Docket Item #26
SPECIAL USE PERMIT #2003-0115

Planning Commission Meeting
May 4, 2004

ISSUE: Consideration of a request for a special use permit to construct a single family on a substandard lot and a parking reduction.

LOCATION: 301 Laverne Avenue

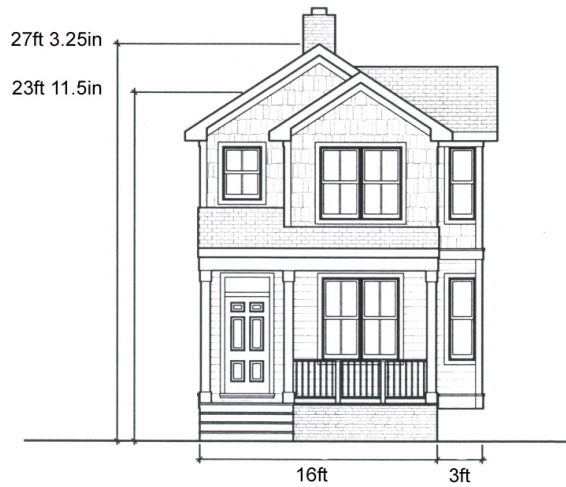
The zoning ordinance recognizes that building a house on a lot that is not as large as the zone may require modifications of the standard zoning rules. Staff can support modifications when they help create development in a way that is more consistent with its immediate surroundings and with the established pattern in the neighborhood than strict compliance with the zoning ordinance would allow. Staff found the substandard lot case being heard at 2001 LaGrande Avenue (SUP#2004-0020) to be an example of the point. In the subject case, however, although some of the modifications are supportable in the abstract, others show how difficult it is to build the applicant's proposed house on this very small lot.

The applicant in this case surveyed the front setbacks of a number of corner properties in the vicinity of the subject property and found that the majority have setbacks less than what the zoning currently requires. The area was built, in the main, prior to the adoption of the current zoning requirements, so the applicant's findings are not surprising. In addition, the surveyed properties are larger than the subject parcel, and in some cases are developed with semi-detached dwellings, discounting their relevance to the requested modifications for the subject property. However, staff agrees that as to the front setback requirement on Laverne, the proposed modification is desirable so as not to have a new house out of character with the others nearby. On the Turner Street frontage however, the small setback (11 feet to the building wall and only eight feet to the large bay windows) is problematic, as it allows a large and long structure (60' long) very close to the street, and completely out of character with the setback of the house behind it.

Staff does not object to a vision clearance modification, in that the streets affected are neighborhood, residential streets, with relatively slow traffic, and because there is a stop sign at Turner Road.

Finally, staff cannot support the rear yard paving modification because the size and location of the house leaves a small side (rear) yard, the parking provided there is not even sufficient to meet zoning requirements and the paving and curbcut require removal of trees.
